## **GRIDER-EDDINS SUBDIVISION**

APPLICATION NUMBER14 DATEJuly 10, 2008	N
APPLICANT Grider - Eddins Subdivision	3
REQUEST Subdivision	A
	NTS

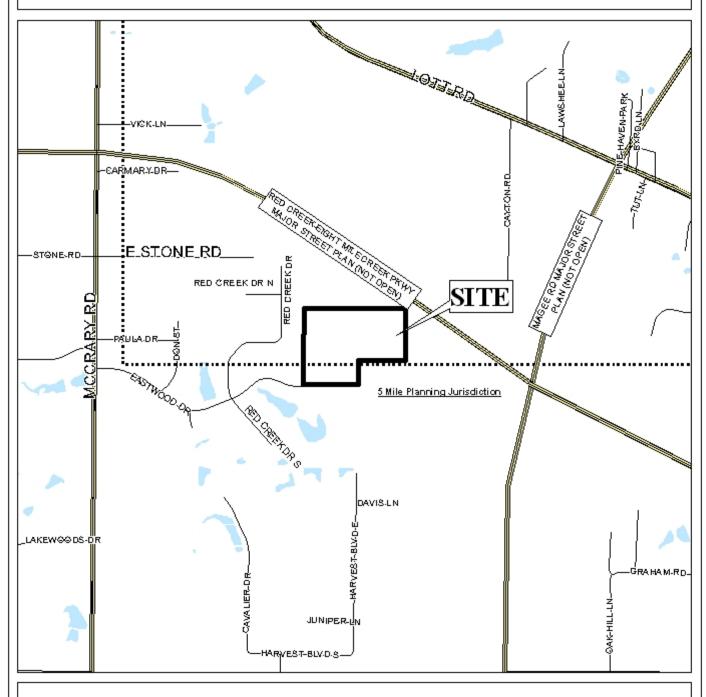
The plat illustrates the proposed 25.0±-acre, 2-lot subdivision which is located on the North side of Eastwood Drive at its East terminus. The applicant states that the subdivision is served by public water and individual septic systems.

The purpose of this application is to create two legal lots of record from two existing metes and bounds parcels. It should be noted that almost all of the proposed Lot 2 is outside the Five Mile Planning Jurisdiction, but the "pole" portion of the proposed "flag lot" enters into the Jurisdiction; therefore the entire subdivision must be considered by the Planning Commission. Available County parcel data from 1997 does not indicate a "pole" across proposed Lot 1 from proposed Lot 2, and also does not indicate the slight protuberance of the North portion of Lot 1 into Lot 2. Parcel data from 2002 indicates the current configuration of the two parcels suggesting that property lines were reconfigured without going through the proper Subdivision process, hence this application.

The Subdivision Regulations were recently amended to include a general prohibition of flag lots, however, they are permitted in instances where varied and irregularly-shaped lot designs are common and the informality of design is consistent with other lots in the vicinity. In this instance, there are existing irregularly-shaped properties in the vicinity, and the adjacent property to the South is a flag lot subdivision approved by the Commission in 2002. Therefore, with a waiver of Sections V.D.1. and V.D.3. of the Subdivision Regulations, the subdivision would be appropriate to the area.

The site fronts on Eastwood Drive with a 60' right-of-way; therefore dedication would not be required. As a means of access management, a note should be placed on the final plat stating that each lot is limited to one curb cut to Eastwood Drive, with the size, location and design to be approved by County Engineering and conform to AASHTO standards. No building setback line is indicated on the plat; therefore, the plat should be revised to indicate a 25' minimum building setback line along the front (South) line of each proposed lot. The lots are not labeled with their areas; therefore, each lot should be labeled with its size in square feet and acres, or a table should be furnished providing the same information.

Another recently-adopted amendment to the Subdivision Regulations pertaining to Environmental and Watershed Protection could have a bearing on the site. The property is located within the Chickasaw Creek Watershed and the amendment pertains to any watershed which contains a public drinking water source. A note should be required on the final plat

stating that if the Chickasaw Creek Watershed contains a public drinking water source, compliance with amended Section V.A.5. of the Subdivision Regulations would apply.

Given the location of streams on the site, it would be considered environmentally sensitive; therefore, the approval of all applicable Federal, state and local agencies would be required prior to the issuance of any permits or land disturbance activities. The geographic area defined by the City of Mobile and its planning jurisdiction, including this site, may contain Federally-listed threatened or endangered species as well as protected non-game species. Development of the site must be undertaken in compliance with all local, state and Federal regulations regarding endangered, threatened or otherwise protected species.

This site is located in Mobile County, thus a note should be placed on the Final Plat stating that any lots which are developed commercially and adjoin residentially developed property must provide a buffer, in compliance with Section V.A.7. of the Subdivision Regulations.

With a waiver of Sections V.D.1. and V.D.3. of the Subdivision Regulations, the plat is recommended for Tentative Approval, subject to the following conditions:

- 1) placement of a note on the final plat stating that each lot is limited to one curb cut to Eastwood Drive, with the size, location and design to be approved by County Engineering and conform to AASHTO standards;

- 2) illustration of the 25' minimum building setback line along the front (South) line of each lot;
- 3) labeling of each lot with its size in square feet and acres, or the furnishing of a table on the final plat providing the same information;

- 4) placement of a note on the final plat stating that if the Chickasaw Creek Watershed contains a public drinking water source, compliance with amended Section V.A.5. of the Subdivision Regulations would apply;

- 5) placement of a note on the final plat stating that the approval of all applicable Federal, state and local agencies would be required prior to the issuance of any permits or land disturbance activities;

- 6) placement of a note on the final plat stating development of the site must be undertaken in compliance with all local, state and Federal regulations regarding endangered, threatened or otherwise protected species; and

- 7) placement of a note on the final plat stating that any lots which are developed commercially and adjoin residentially developed property must provide a buffer, in compliance with Section V.A.7. of the Subdivision Regulations.
